# 1984 Corvette: Service Bulletin: Engine Stops Running When Starting with Air Conditioning "On"

**Subject:** Engine Stops Running When Starting with Air Conditioning "On"  
**Model and Year:** 1984 Corvette with Automatic Transmissions  
**Source:** Chevrolet Dealer Service Bulletin  
**Bulletin No:** 84-240  
**Section:** 8B (XII)  
**Date:** Feb. 1985

**A/C CLUTCH ON REVISED ECM SIGNAL  
INPUT BLOCK DIAGRAM**

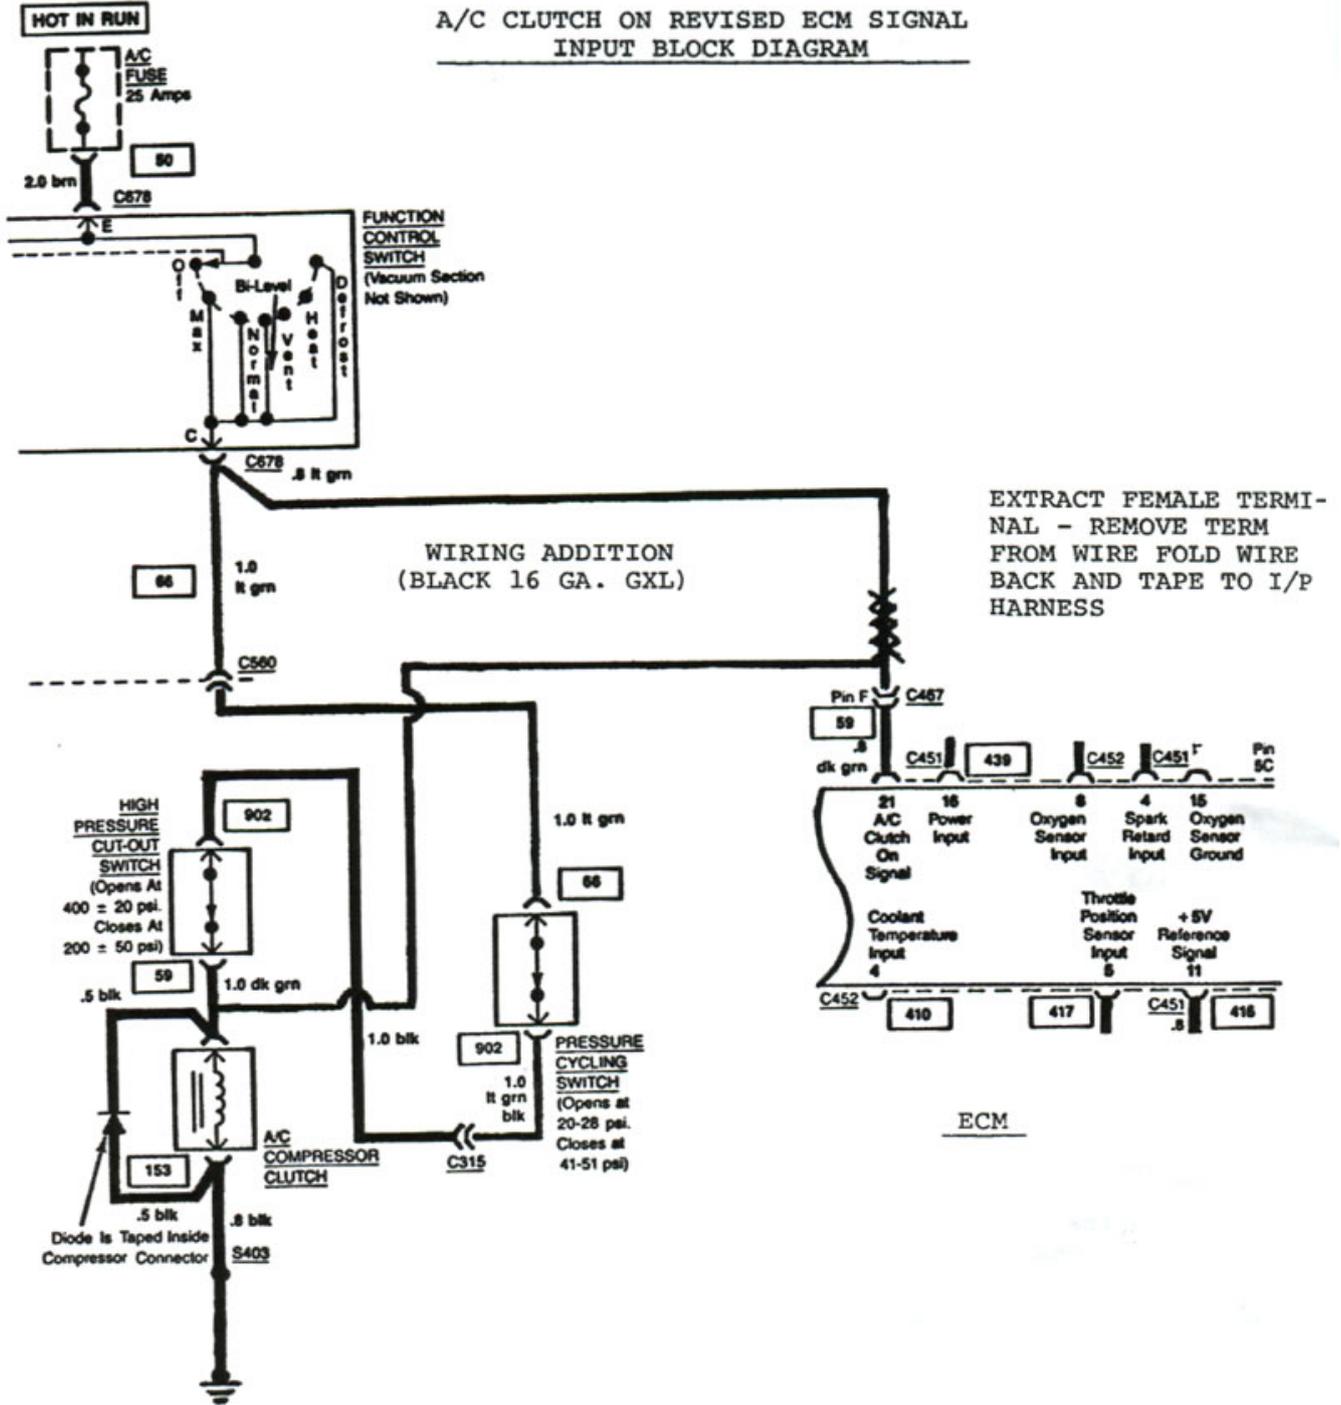
This revision requires installing a 16 Ga. wire into the A/C discrete circuit at connector C-467, Pin F of the I/P to ECM harness, routing the wire through the bulk head connector and splicing into the A/C circuit of the engine, between the pressure cycling switch and the compressor clutch (see block diagram).

FIGURE 1

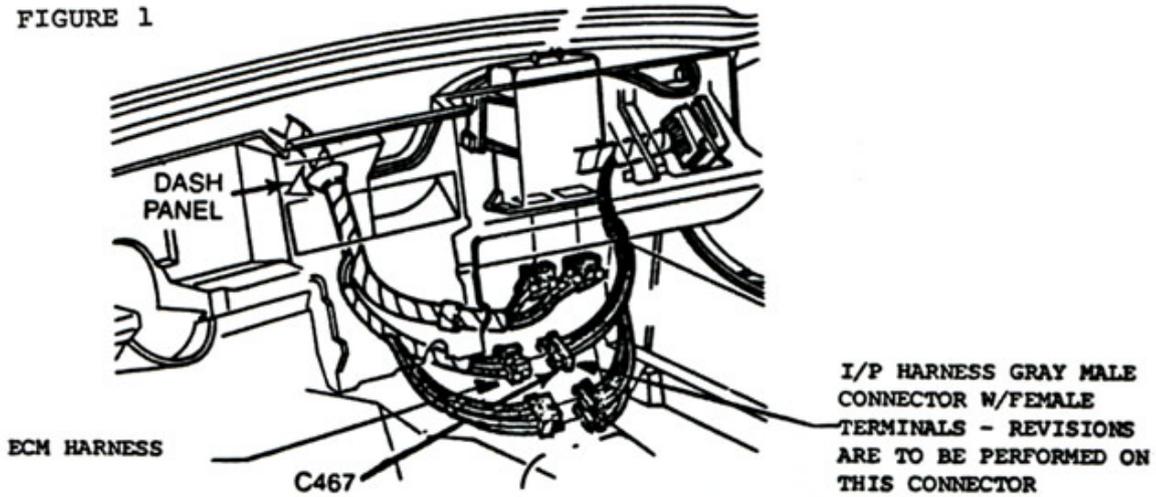
1. Remove I/P upper trim pad assembly. Remove L.H. and R.H. hush panels.
2. Extract female terminal (green wire) from gray I/P to ECM harness connector C-467, circuit 66 (see Figure 1.)
3. Cut off and discard extracted female terminal. Fold severed green wire back and tape it to the I/P harness, making sure the severed wire end is well insulated with electrical tape.
4. Utilize the 22 feet of 16 Ga. GXL black wire by stripping one end and crimping, P/N 12015856, female terminal on the stripped end. Insert the new terminal into connector C-467, Pin F.

FIGURE 2

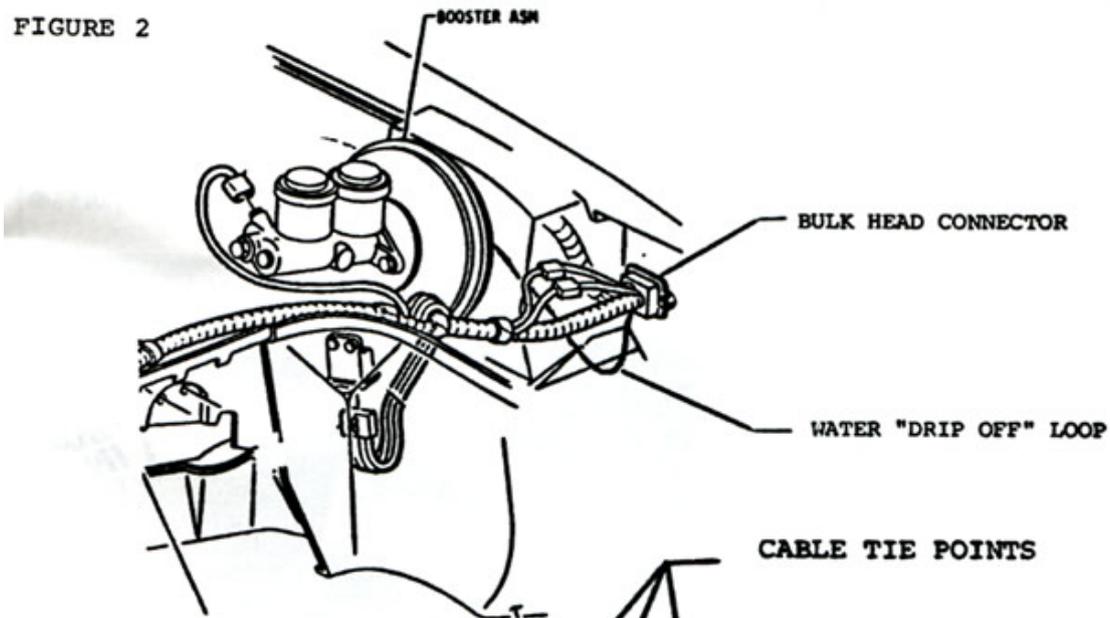
6. Using masking tape, secure the signal wire to the A/C ducts to avoid wire abrasion and rattles.
7. Remove I/P harness bulk head caps on the passenger compartment side, as well as the engine compartment side. DO NOT disconnect the bulk head connectors.
8. Feed the signal wire through the open (unused) bulk head, Pin #E4, located adjacent to a 12 Ga. red wire. it may be necessary to strip the feed end of the signal wire approximately two (2) inches from the end and "solder tint" the wire to aid in guiding the wire through the bulk

FIGURE 3

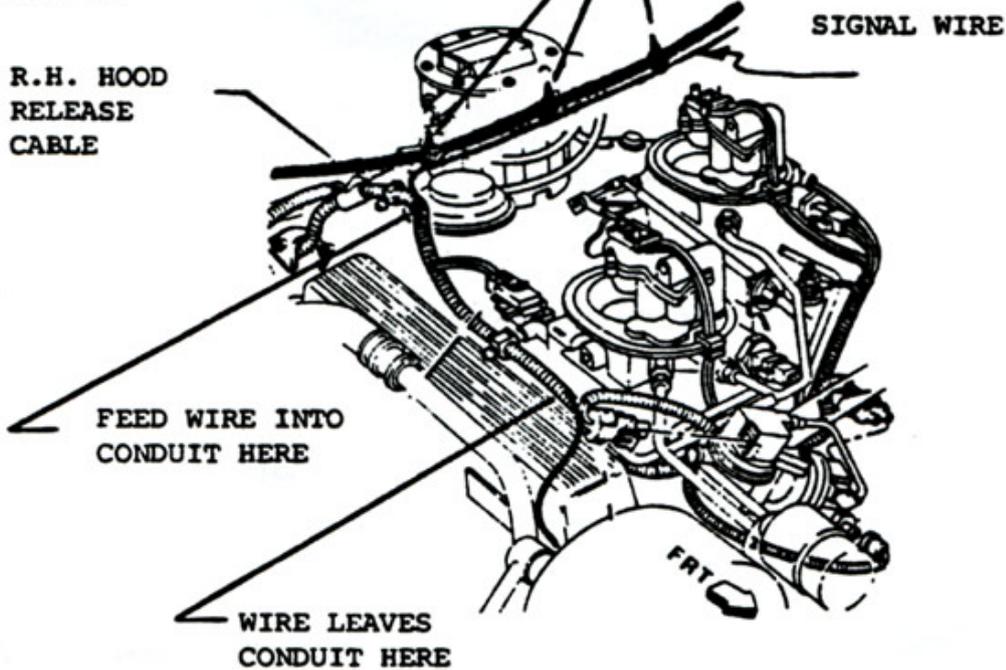
9. Once the signal wire has been fed through the bulk head connector, grease is to be packed around the signal wire at both sides of the connector. This step assures an adequate bulk head connector to signal wire seal.
10. Reinstall the bulk head harness caps.
11. Loop the signal wire down below the bulk head connector and back up behind the brake booster (see Figure 2.)
12. Route the signal wire along the R.H. hood release cable securing the wire to the cable with three (3) cable ties.
13. At the R.H. rear corner of the engine, direct the wire to the front of the engine and install it in the existing engine harness conduit (see Figure 3.)

**FIGURE 4**

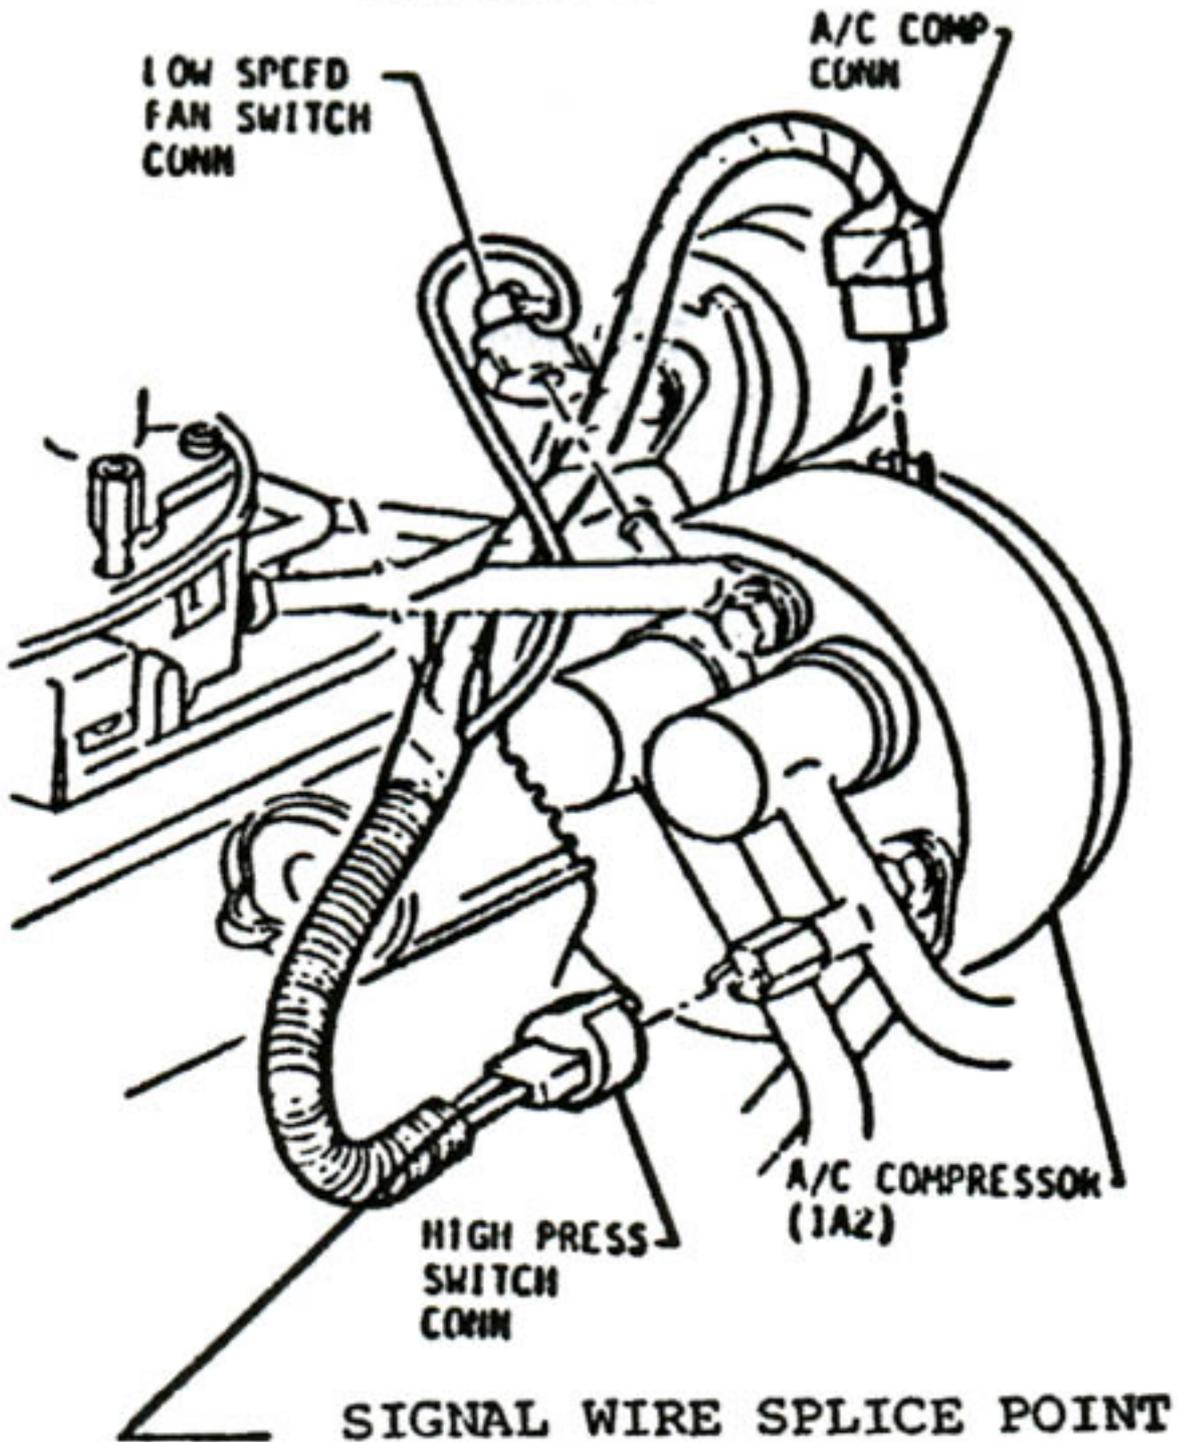
14. Remove the harness end tape and strip the insulation back .5 inches on the green wire at the high pressure A/C switch connector (see Figure 4.)
15. Remove excess signal wire length, if necessary, and strip end back .75 inches. Wrap the signal wire around the A/C clutch green wire and solder to insure a good connection.
16. Retape harness at high pressure switch connector.
17. Reinstall I/P upper trim panel and hush panels.
